CONTRACT CHANGE ORDER

CCO: 240 Suppl. No. 0 Contract No. 04 – 0120F4 Road SF-80-13.2/13.9 **FED. AID LOC.:**

The following revised plan sheets detail the changes addressed in this change order: 748R2, 749R2, 752R4, 753S1R3, 753S3R1, 769S1, 769S2, 777R2, 778S2R1, 779R1, 786R2, 788R1, and 788S1 (of 1204) as shown on sheets 2 through 14 of this change order.

SAN FRANCISCO OAKLAND BAY BRIDGE
EAST SPAN SEISMIC SAFETY PROJECT
SELF-ANCHORED SUSPENSION BRIDGE (SUPERSTRUCTURE & TOWER)

SLOTTED SHIM DETAIL

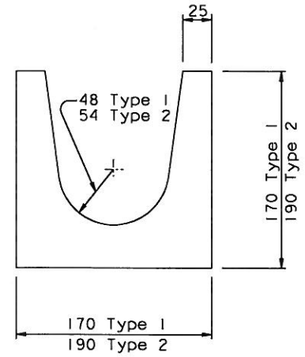
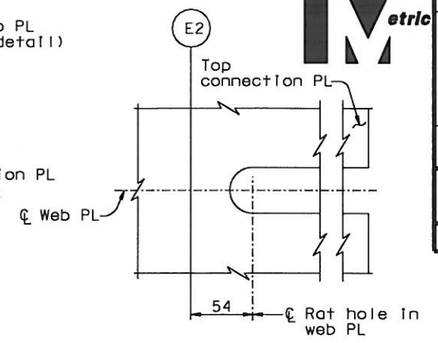
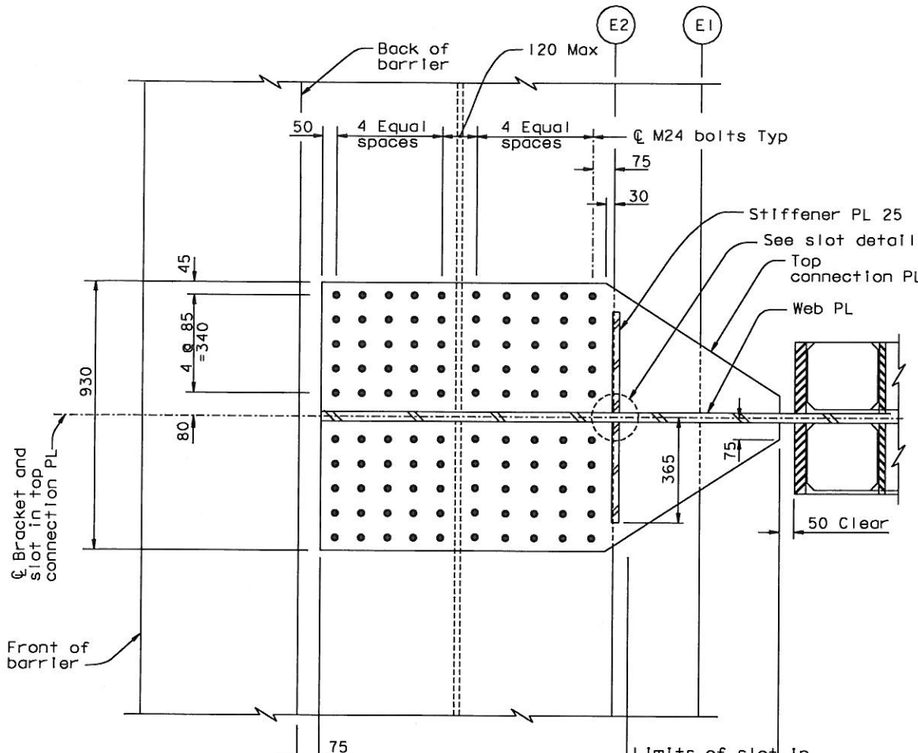
MARK	DATE	DESCRIPTIONS	BY	CH'D	CCO#
2	04/05/12	SUSPENSION SYSTEM SHIMS	GB	MN	240
1	04/16/07	CABLE SYSTEM	GB	DT	37

SLOTTED SHIM DETAIL

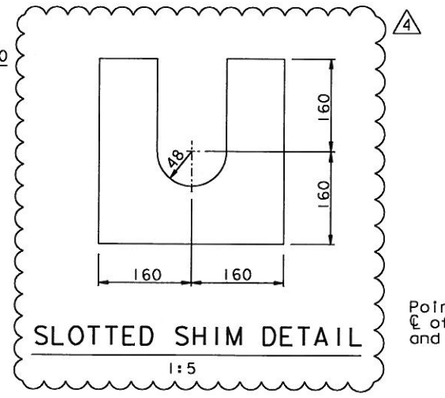
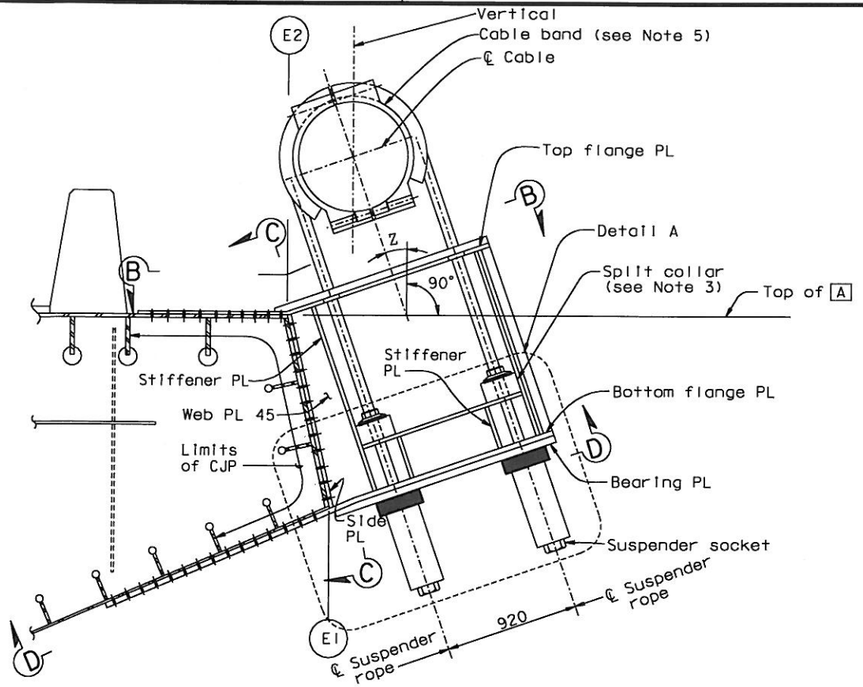
MARK	DATE	DESCRIPTIONS	BY	CH'D	CCO#
4	04/05/12	SUSPENSION SYSTEM SHIMS	GB	MN	240
3	02/20/09	SUSPENDER BRACKETS	GB	DT	104
2	08/15/08	CABLE ELECTRICAL	GB	DT	72
1	04/16/07	CABLE SYSTEM	GB	DT	37

1. Threaded rod may be used for erection. After installation of suspender socket, ends shall be sealed with 90 Dia A307 bolts.
2. For details not shown, see "Suspender Bracket Details No.1" through "Suspender Bracket Details No.3" sheets.
3. For split collar details, see "Suspender Bracket Details No.5" sheet.
4. The Contractor shall consider variation in roadway grade in his details.
5. For cable band details, see "Cable Band Details" and "Cable Handrope Details" sheets.
6. For suspender brackets at PP 108 and PP 110, see "Suspender Bracket Details No.8" and "Suspender Bracket Details No.9" sheets.
7. For shim stack heights, see "Suspender Bracket Details No.10" sheet.

WEST DEVIATION SADDLE DETAILS NO. 6

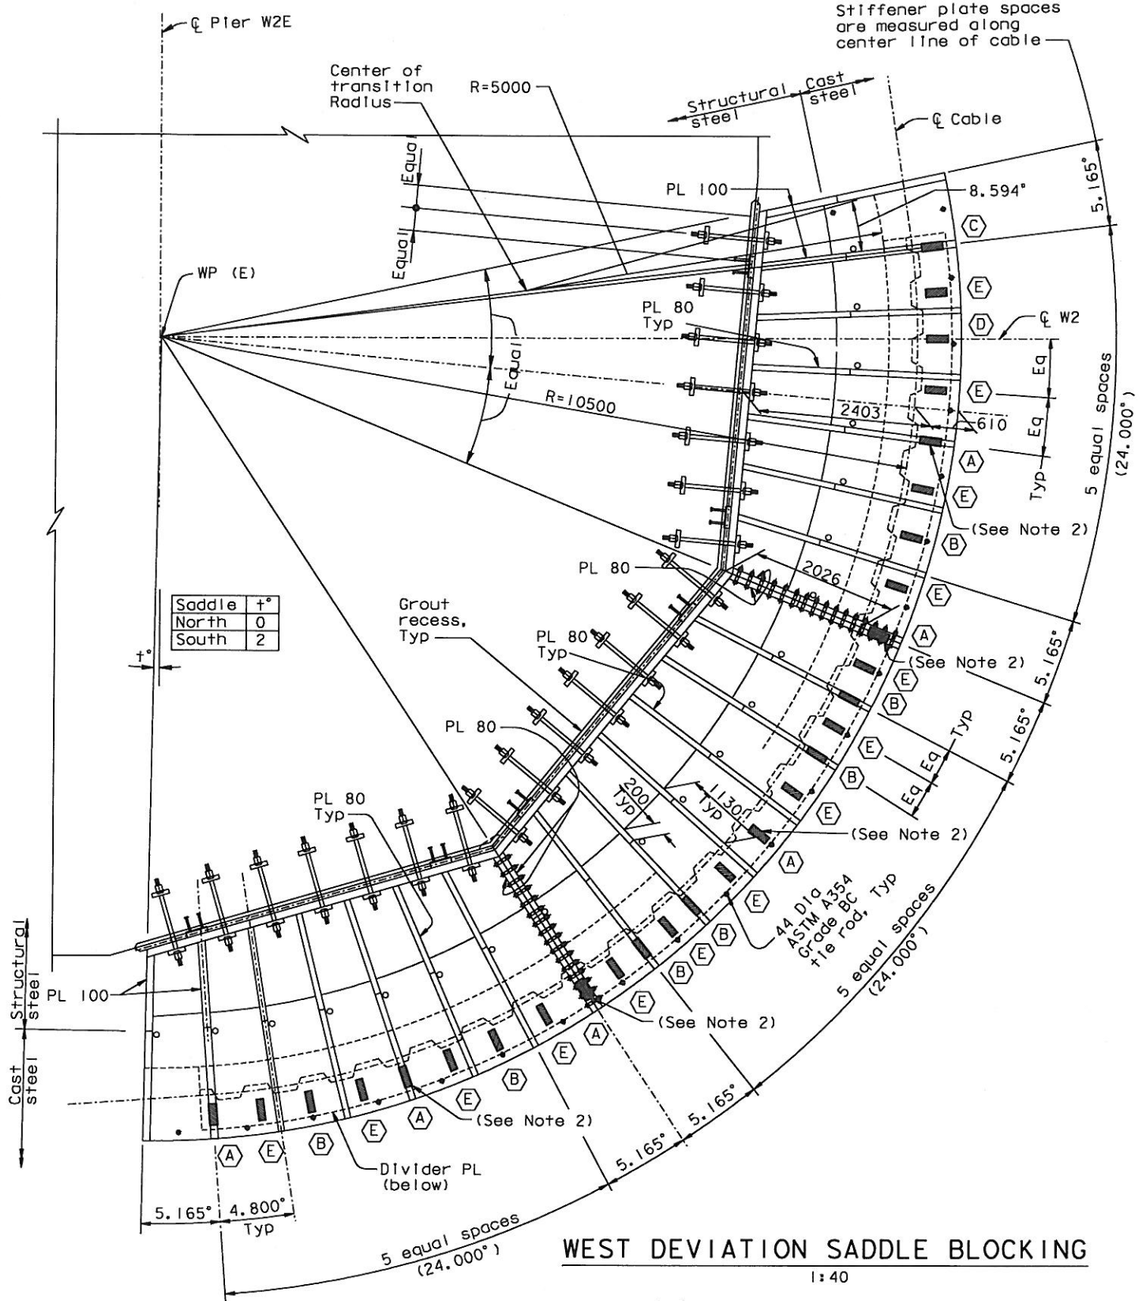
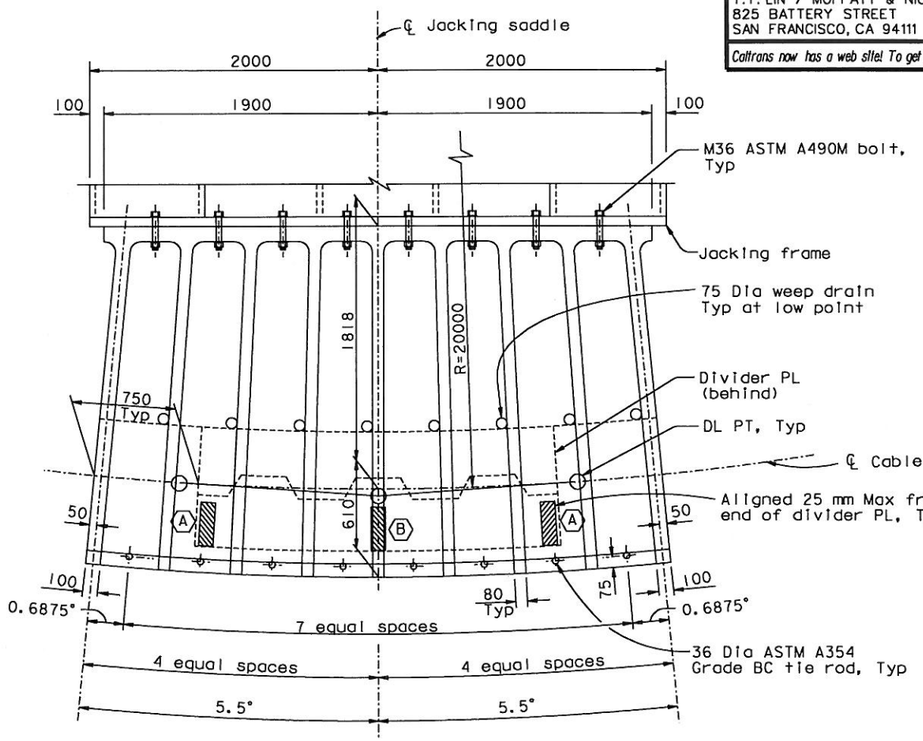
MARK	DATE	DESCRIPTIONS	BY	CH'D	CCO#
0	05/09/12	SADDLE BLOCKING	GB	MN	240

1. For blocking types and details, see "West Deviation Saddle Details No. 7" sheet.
2. Blocking at these locations shall straddle the as-built divider plate radial joint.

SAN FRANCISCO OAKLAND BAY BRIDGE
EAST SPAN SEISMIC SAFETY PROJECT
SELF-ANCHORED SUSPENSION BRIDGE (SUPERSTRUCTURE & TOWER)
WEST DEVIATION SADDLE DETAILS NO. 7

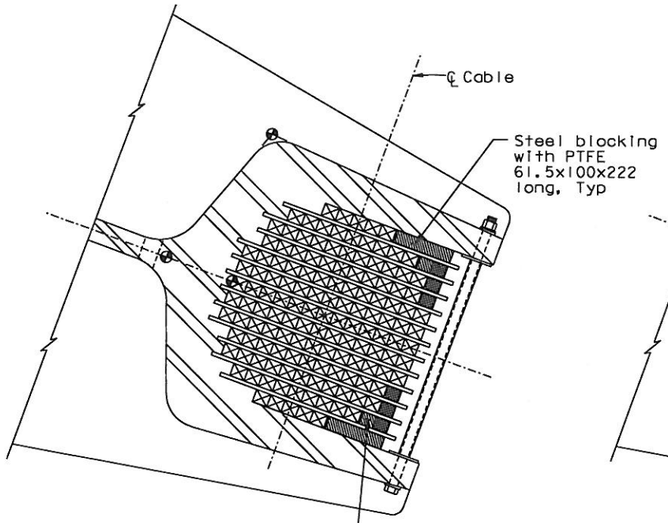
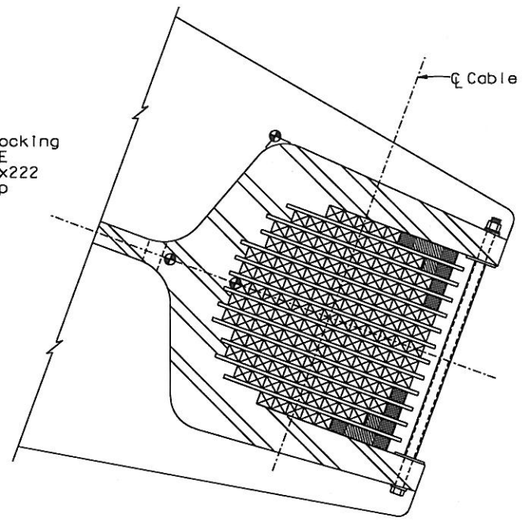
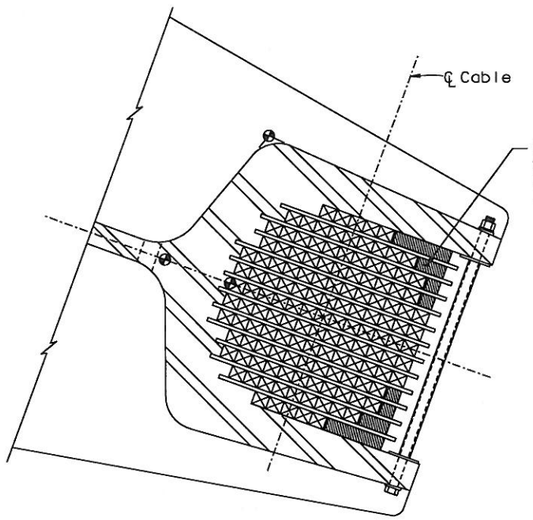
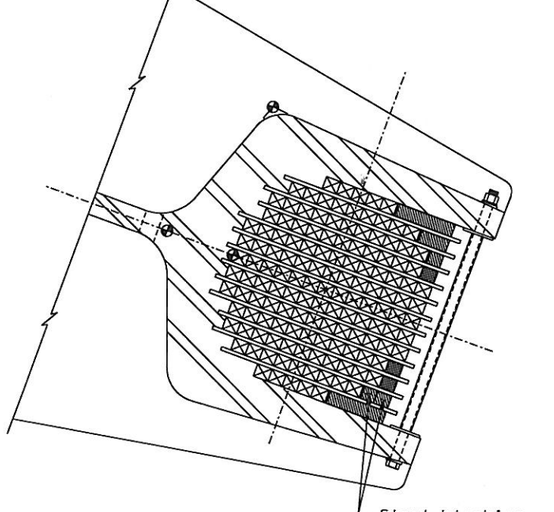
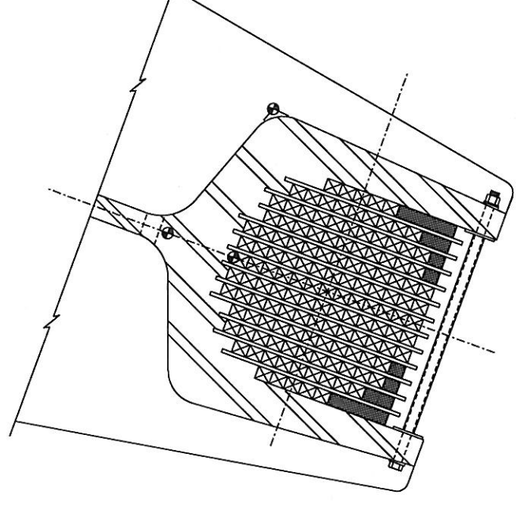
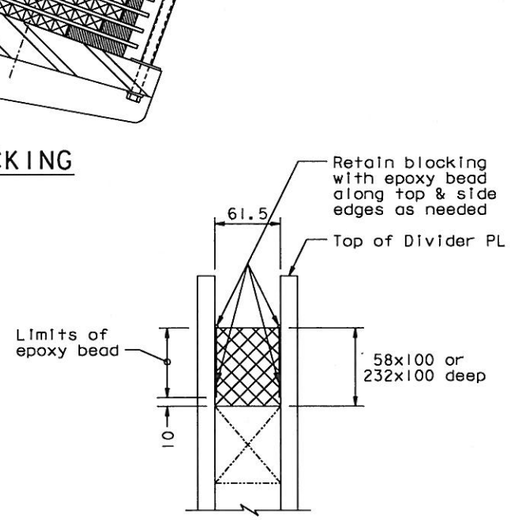
MARK	DATE	DESCRIPTIONS	BY	CH'D	CCO#
0	05/07/12	SADDLE BLOCKING	GB	MN	240

1. Steel blocking fabricated for Tower saddle shall be used for West deviation and jacking saddles.
2. At the Contractor's option, hardwood shims and blocking may be used in lieu of UHMWP.
3. The completed blocking at each location is fabricated to fit tightly. Should tight fit not be achieved, the Contractor shall inform the Engineer for evaluation.

TOWER SADDLE DETAILS NO. 4

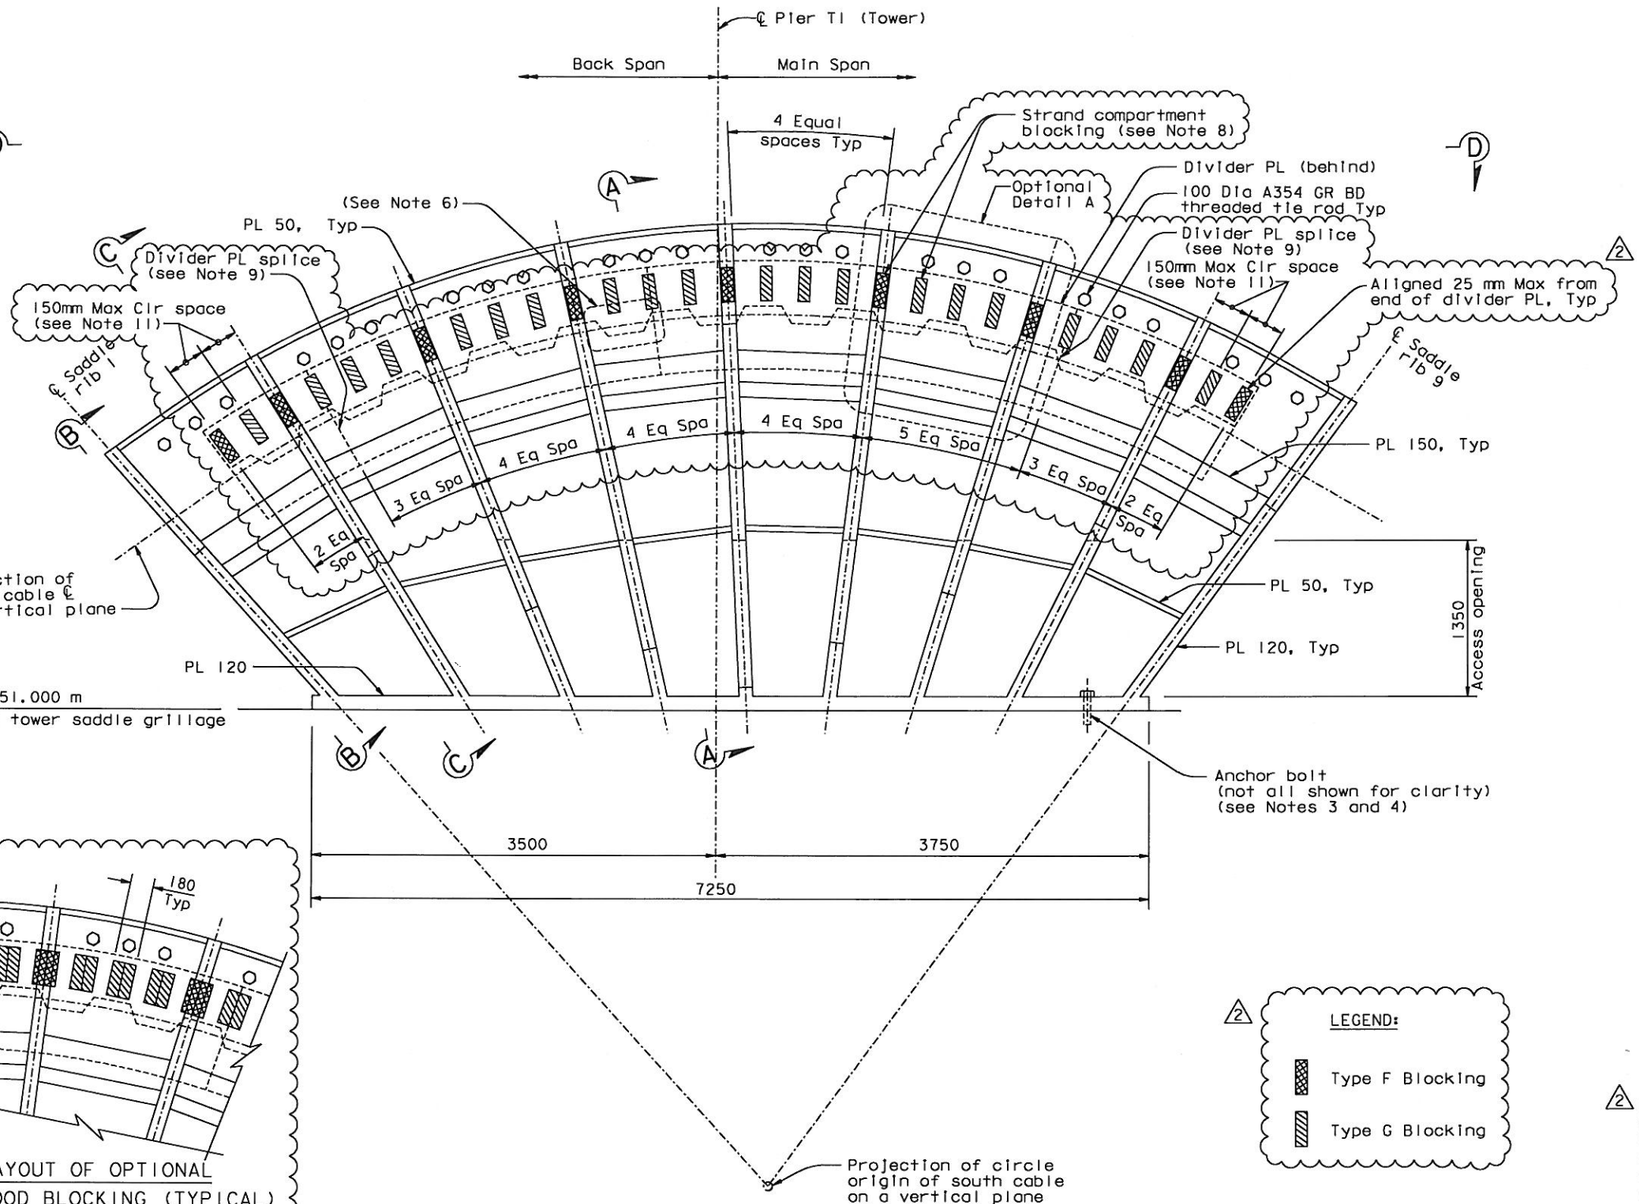
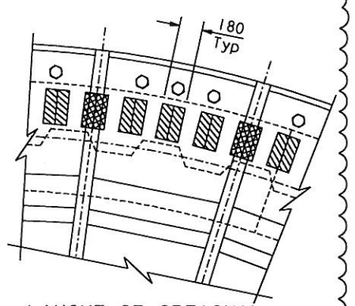
MARK	DATE	DESCRIPTIONS	BY	CH'D	CCO#
2	05/09/12	SADDLE BLOCKING	GB	MN	240
1	10/31/08	TOWER HEAD DETAILS	MN	GB	93

2 8. Contractor shall fabricate and install new blocking. For layout, see "Tower Saddle Details No.5B" sheet. For blocking details, see "Tower Saddle Details No.6" sheet.
9. The blocking shall be placed such that it straddles the divider plate spacing joint.
10. At the Contractor's option, hardwood blocking may be installed and left in place through load transfer. Hardwood blocking shall be installed in widths of 180 mm, and cut on site to fit tightly at each blocking location. After load transfer, hardwood blocking shall be left in place or replaced as directed by the Engineer.
11. Where clear distance adjacent to G blocking exceeds 150 mm, the Contractor shall install additional 90 mm wide Type G blocking in the space.

TOWER SADDLE DETAILS NO. 5B

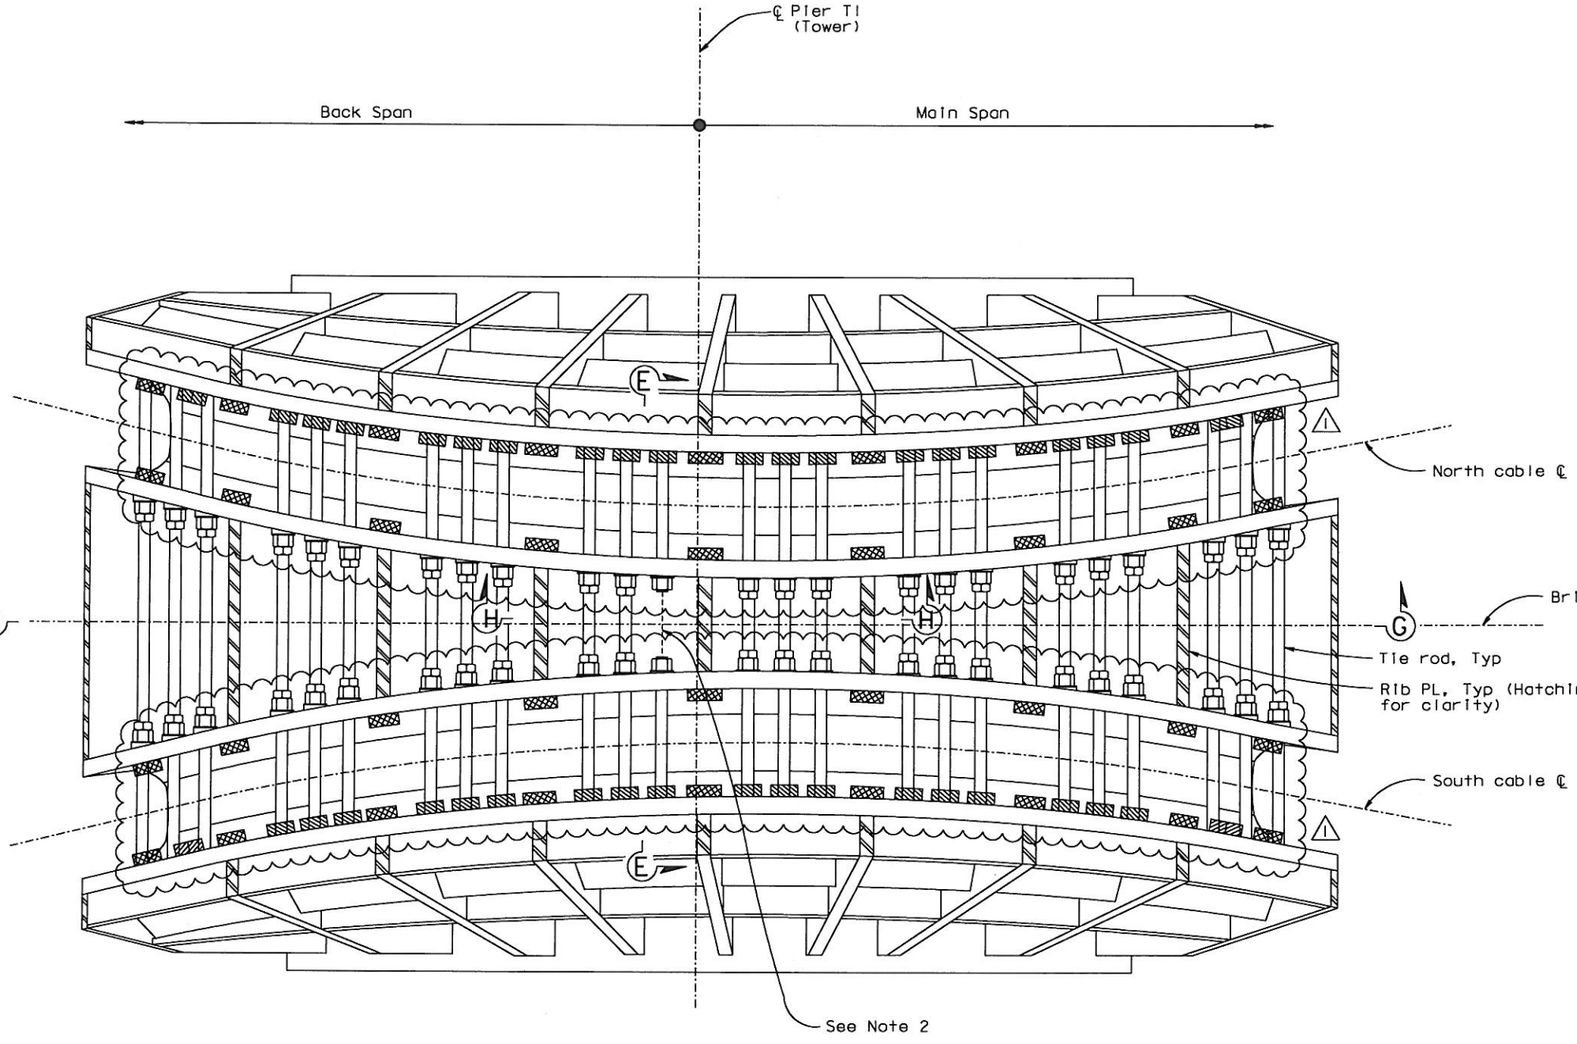
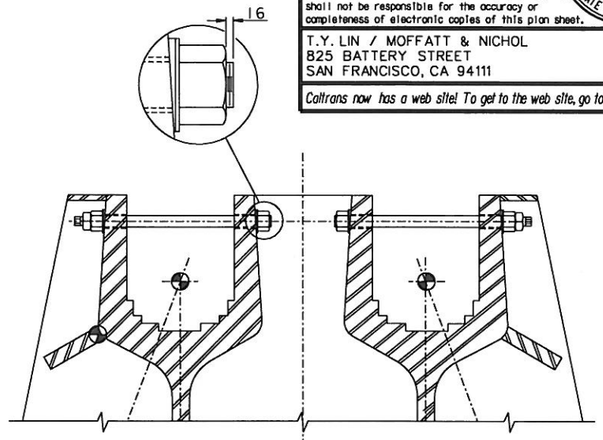
MARK	DATE	DESCRIPTIONS	BY	CH'D	CCO#
1	05/07/12	SADDLE BLOCKING	GB	MN	240
0	10/31/08	TOWER HEAD DETAILS	NV	MN	93

NOTES:
1. For Section G-G, see "Tower Access Details No. 23" sheet. For Section H-H, see "Tower Saddle Details No. 5A" sheet.
2. Tie rod is discontinuous between saddle troughs at this location only.
3. For blocking, see "Tower Saddle Details No. 6" sheet.
